ADDENDUM #1
July 25, 2024
Fort Chiswell South Sewer Extension Phase I
Wythe County

WYTHE COUNTY
FORT CHISWELL SEWER EXTENSION
ADDENDUM 1
DRAWING A1-1
JULY 2024

**PREBID CONFERENCE MINUTES
23 July 2024, 10:00 A.M.
Fort Chiswell South Sewer Extension Phase I
Wythe County**

CONCRETE GENERATOR PAD DETAIL

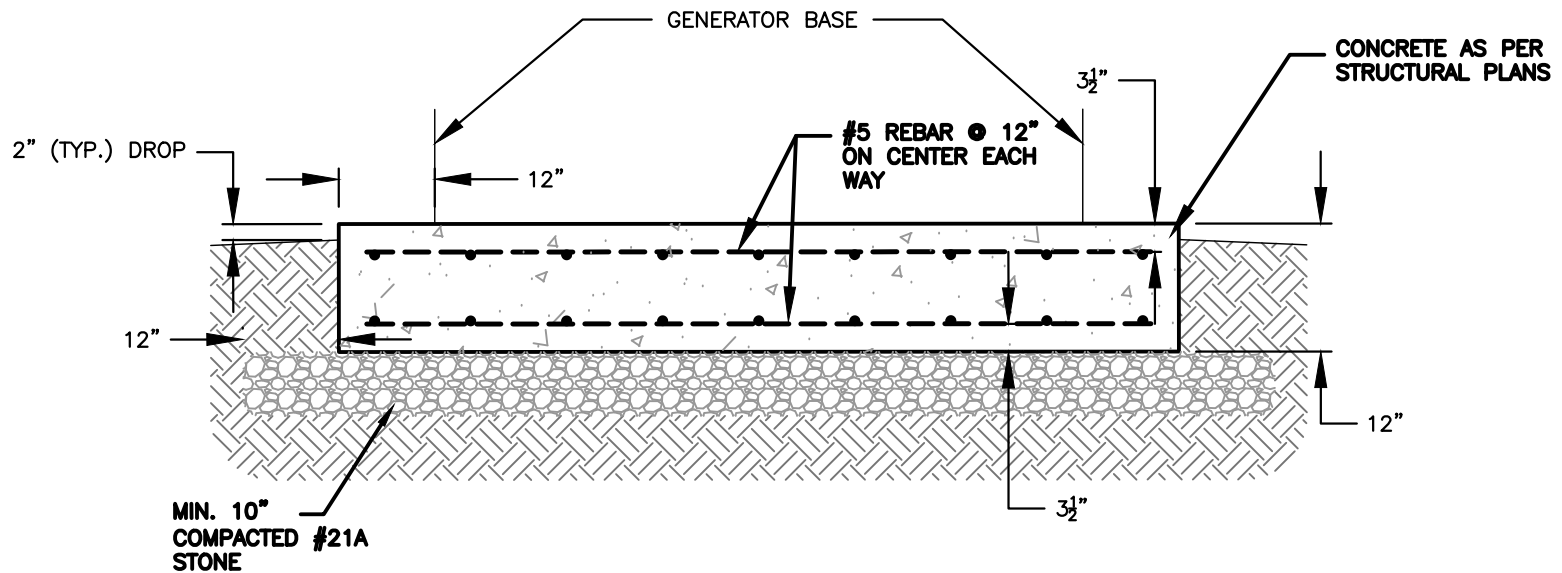
1. Add drawing A1.1 to Drawing D03 for the generator pad detail.

NOTE:
GENERATOR PAD SIZE BASED ON KOHLER 40REOZK GENERATOR
WITH GENERATOR BASE DIMENSIONS OF 91.3" L X 42.1" W.
CONTRACTOR SHALL CONSTRUCT PAD WITH A MINIMUM OF 12" OF
CLEARANCE ON EACH SIDE OF GENERATOR BASE.
